Product Change Notification / JAON-11LCXQ578

CCB 3061.002 Final Notice: Implementation of a new Chip ID 0x8A5C08C4 for component U2 of ATSAM5D27-SOM1 catalog part number (CPN) available in 176L (40x38x6.34mm) module package.

CCB 3061.002
Component U2 Location
PCN#: JAON-11LCXQ578

Component U2 Location

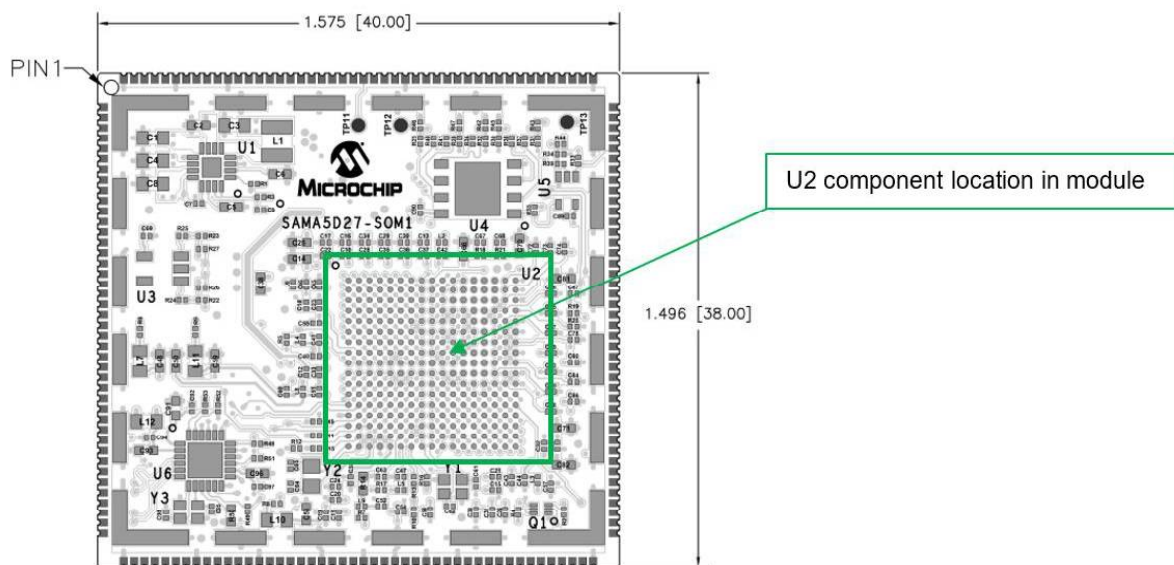
Note: No change to the location of component U2. The only change will be the Chip ID.
